9.1 INCLUSIVE DESIGN STATEMENT

The following points summarise the key changes to the design relating to inclusive design, as well as some clarifications, since the submission in December 2019.

This Design & Access Statement Addendum has outlined the design developments to the scheme since the original submission for full planning permission in December 2019. The enhancements to the scheme described are a response to consultee and stakeholder feedback and represent a significant material improvement to the public benefit of the scheme.

Visual of the scheme submitted in December 2019

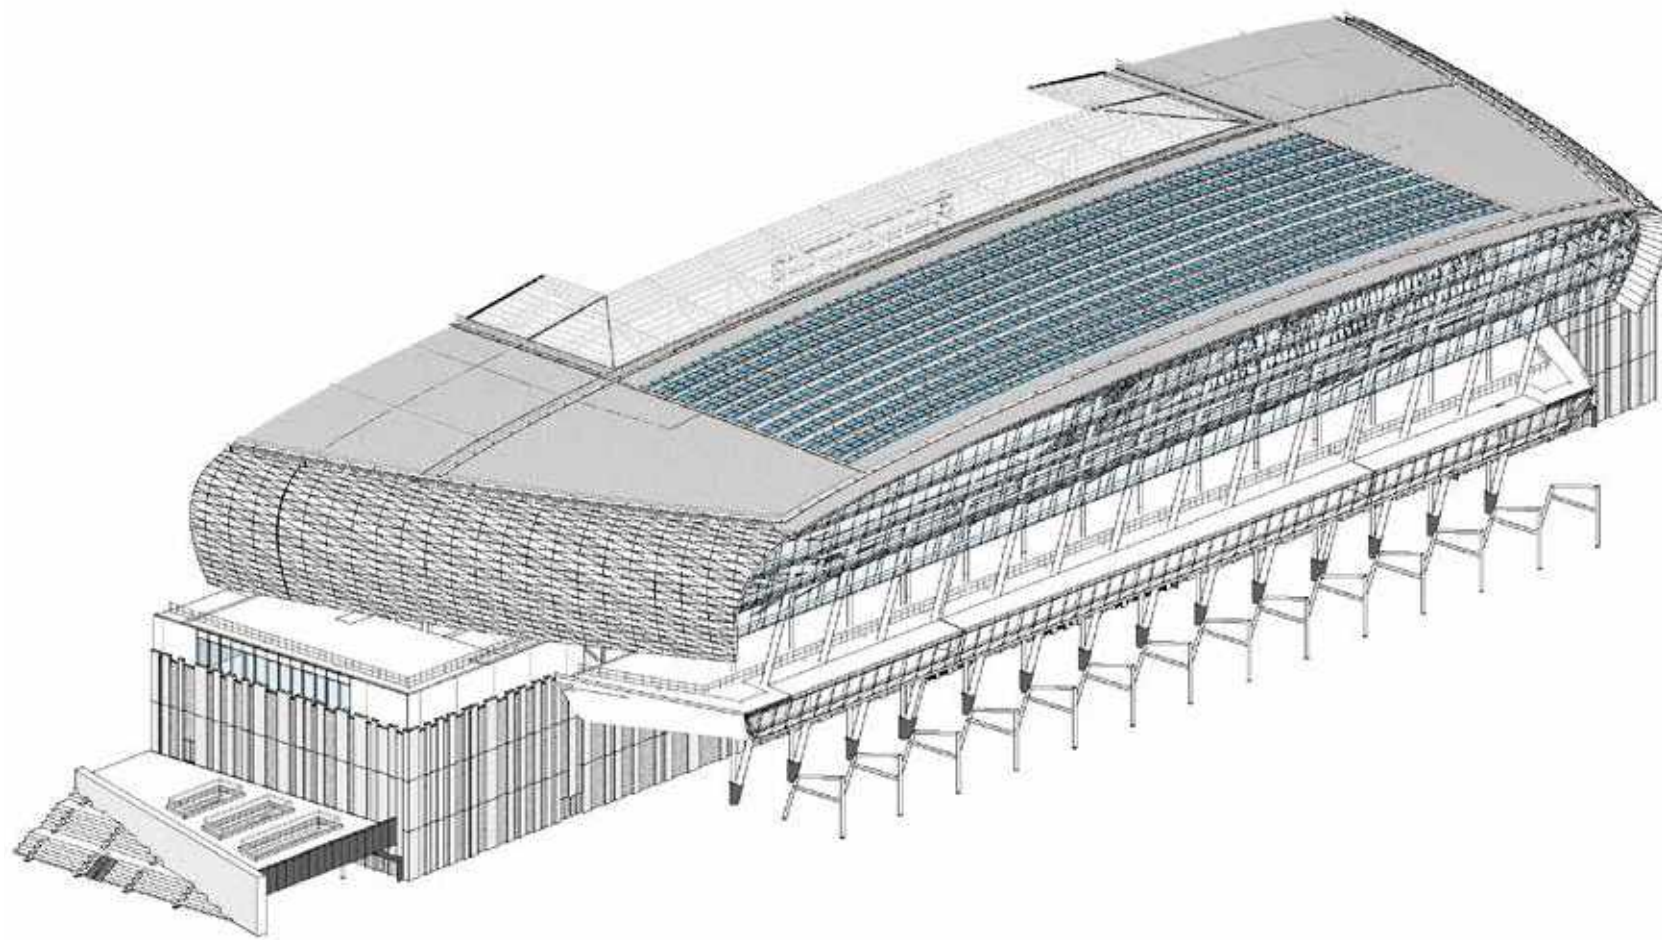
In the scheme submitted in December 2019, the Photovoltaic (PV) Array was mounted to a canopy which covered the west quay surface car park. Upon review of the scheme, it was decided that the canopy obstructed views of the river and meant the west quay was an inflexible space, as can be seen in the image opposite.

In the updated proposal the PV array has been relocated to the barrel roof of the stadium. The roof-mounted array maintains the 2050m² area of PV panels in the previously submitted scheme. This exceeds the area required to comply with Part L of the Building Regulations. The roof mounted Building Integrated PV (BIPV) will sit on a frame above the standing seam construction and clipped back to it as indicated in the image opposite.
